VCS VERIFICATION/CERTIFICATION REPORT

HEBEI KANGBAO SANXIATIAN WIND FARM PROJECT IN CHINA

VERIFICATION PERIOD:

REPORT No. 2011-9482

Figure 1 Diagram of meters installation

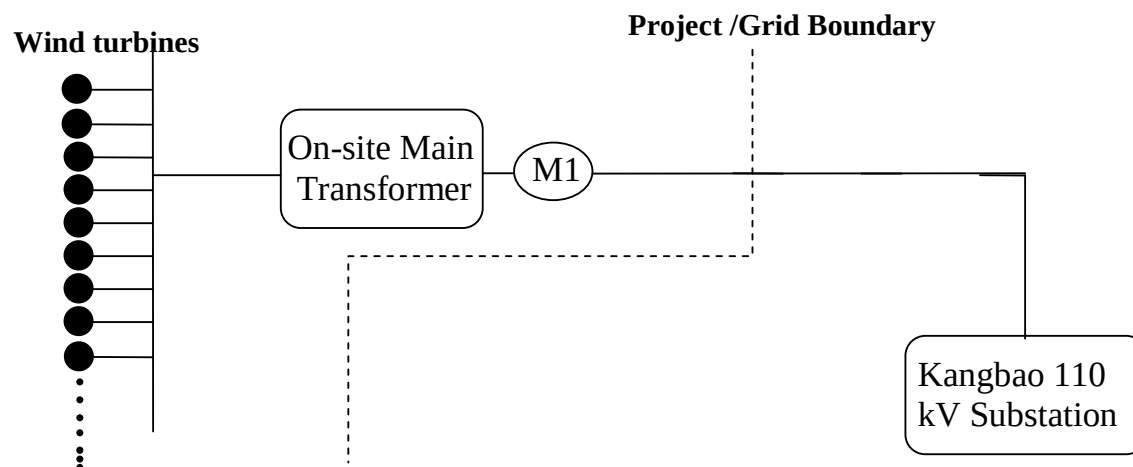
The installation of the monitoring meter M1 is shown in Figure 1 below. The main meter M1 (Serial No. 09070111440058) with the accuracy level of 0.2s was installed at the high voltage of the 110 kV transformer at project site and belong to the project owner. The accuracy 0.2s of M1 is consistent with the monitoring plan of registered PDD /2/ and meets the requirement of power industry code (DL/T 448-2000) /28/ and thus deemed acceptable by DNV. The main meter M1 was used by project owner to measure the electricity exported to the grid as per PPA /8/, which is fully consistent with PDD /2/. The readings of meter M1 were continuously measured and monthly recorded by the project owner. On the last day of every month, the project owner and the grid company jointly read the main meter M1 and after the readings were confirmed by both sides the grid company issued the monthly electricity sales receipts /12/.

The installation and operation of the monitoring meter M1 was checked through visual inspection at the project site during site visit. The monitoring meter was consistent with the monitoring plan contained in the registered PDD /2/. The meter was calibrated once a year /14/ which is consistent with the monitoring plan of the registered PDD /2/.

CAR ID	Corrective action request	Response by Project Participants	DNV's assessment of response by Project Participants
CAR 1	During the site visit, a back up line is found at the project site which is used for the emergency usage. The meter information which monitors electricity usage from the back up line should be clearly indicated in the monitoring report, like the meter location, accuracy, series number etc. DNV has checked the registered documents of the project downloaded from UNFCCC website. There is no information about this back up line and the meter for monitoring this back up line. The inconsistent for this situation and the registered PDD should be clarified.	If the 110kV main transmission is out of work, electricity needed would be imported via the backup line. As is shown in the primary system diagram, the electricity is firstly boosted its voltage to 35kV by station transformer and then delivered to low voltage side of main transformer of project 0878 via 35kV bus. After boosted its voltage, the electricity is transmitted to project 3312 via 110kV bus. On the other hand, if considering project 3312 as a black box, it is obvious that there is only one passageway between the grid and project 3312, that is, 110kV transmission line in which the monitoring meter of project 3312 is installed. Therefore, the electricity imported into project 3312 will be definitely recorded by the monitoring meter, no matter where the electricity sources from. Therefore, the monitoring plan of project 3312 is complete and rigorous though without information about the backup line and monitoring meter.	OK. DNV checked the primary system diagram for the proposed project during site visit /17/. It can confirm that the backup line is only connected to- and used for the project "Hebei Kangbao Wolongtushan 30 MW Wind Farm Project" (ref. No. 0878). This can be reflected from revised PDD for "Hebei Kangbao Wolongtushan 30 MW Wind Farm Project" (ref. No. 0878) /7/. All the import electricity and export electricity for the proposed project is monitored by meter M1. DNV can confirm that there is no need to consider the back up line which was investigated during site visit. The emission reduction related to backup line is eliminated from the emission reduction calculation which is reflected on the updated ER calculation spreadsheet /9/. CAR 1 is closed.

The VCS MR has been revised in accordance with the monitoring plan specified in the registered CDM-PDD.	
--	--	---	--
